Browns Ferry Unit 2 IPE: Front End Review

Technical Evaluation Report  
NRC-04-91-066, Task 11

Science and Engineering Associates, Inc.

Prepared for the  
Nuclear Regulatory Commission

Figure 2.1-1. RCIC at -122, 1 SRV Open

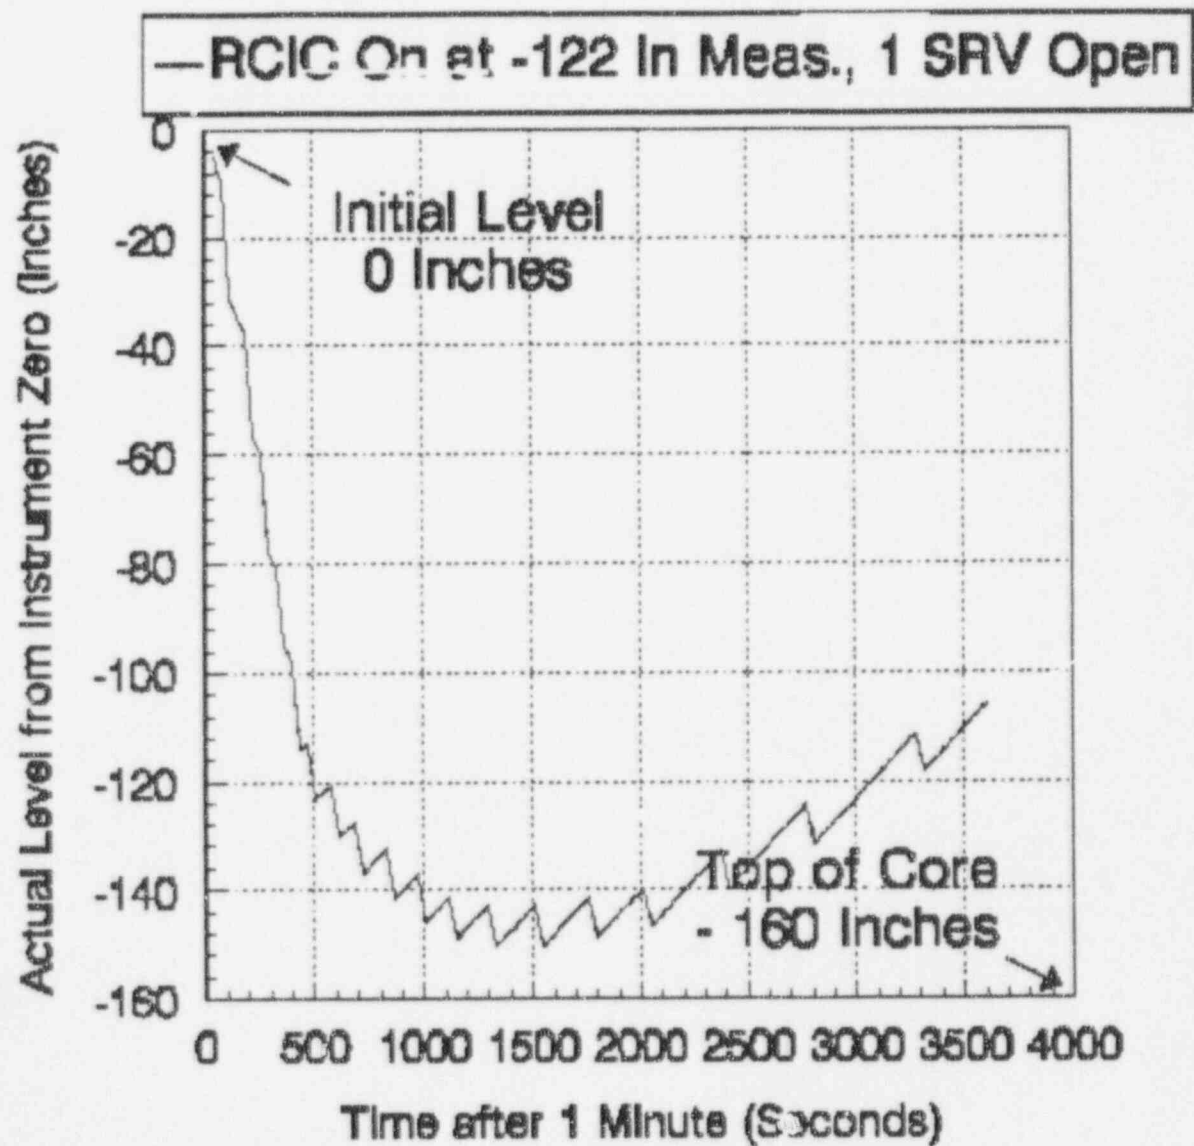
The IPE modeled RCIC as a viable core cooling system for transients and small LOCAs, and claimed that RCIC will successfully cool the core if one SRV is stuck open. [IPE, page 3.1.2-22] Furthermore, the IPE states that RCIC can be manually initiated as late as -122 inches level (where the MSIVs isolate); the auto-initiation setpoint for RCIC is -45 inches. 10 to 15 minutes is stated to be available for this manual initiation of RCIC. [IPE, page C9] The support information for this model is confusing. The discussion references a calculation indicating that 26 minutes are available, but the calculation does not consider an SRV to be failed open. [IPE, page C9 and Table C8] The discussion indicates that the time to automatic RCIC isolation is 10 to 15 minutes, thus 10 to 15 minutes is conservative time to reach -122 inches; however, it is not clear if this time to auto-isolation considers an SRV failed open.

We performed an independent calculation for RCIC using an SEA code developed for Grand Gulf, modified for Browns Ferry. The code is discussed in Appendix A of this report. Figure 2.1-1 provides our results for the case of 1 SRV failed open. This figure indicates that the -122 inch level is reached at about 10 minutes, and that if RCIC is manually initiated at this level the core will not uncover.

The IPE model for RCIC, including times available for operator actions, appears correct based on our independent analyses; however, the supporting information provided in the IPE is confusing.

Figure 2.1-2 Boil on SRVs, No Makeup

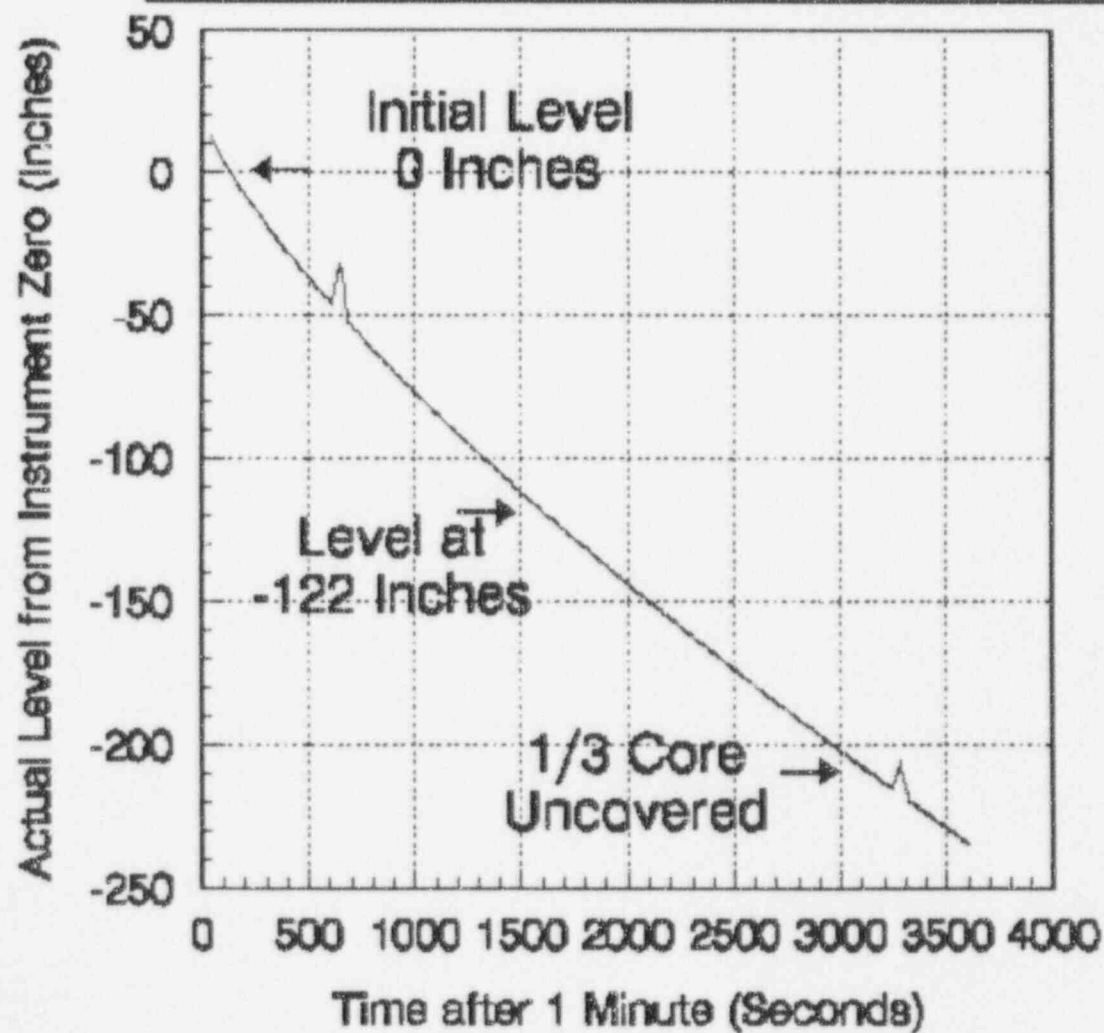
Figure 2.1-2 provides our results for the case with no SRVs failed open. This figure indicates that -45 inches is reached at about 10 minutes and -122 inches is reached at about 25 minutes.

Figure 2.1-3. Loss of Injection at 4 Hours

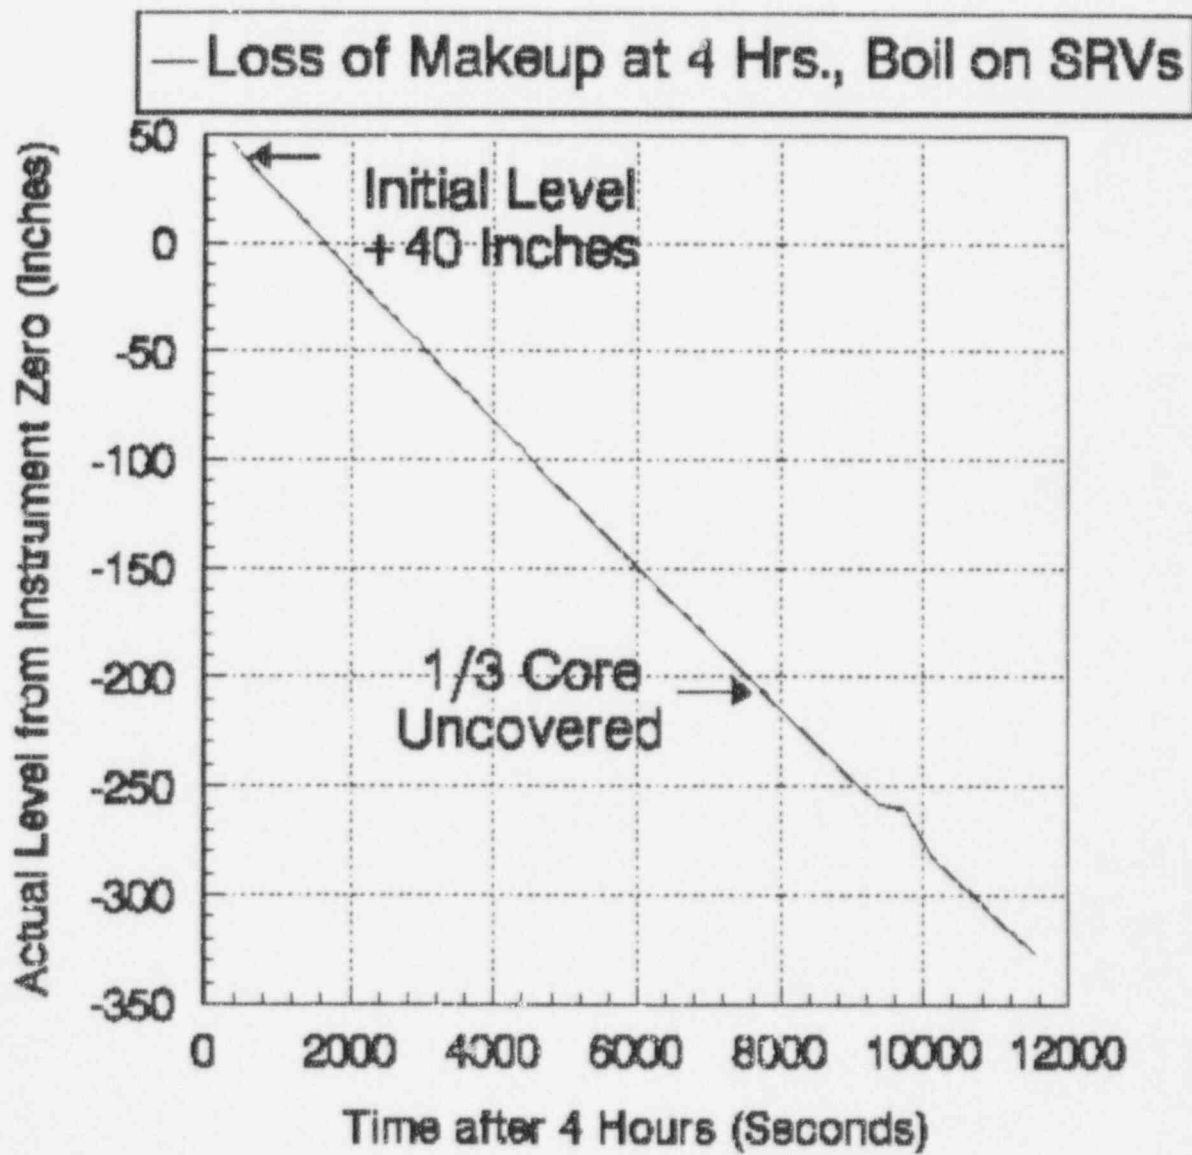
The 6-hour time frame corresponds to a scenario in which HPCI or RCIC inject for 4 hours until batteries deplete; it is stated that analyses were performed indicating that 1/3 core uncover occurs in an additional 2.5 hours. An independent analysis of this scenario was performed with the software discussed in Appendix A. Figure 2.1-3 provides results; the time of 1/3 core uncover is estimated to occur at about 2 hours. The IPE times are reasonable.
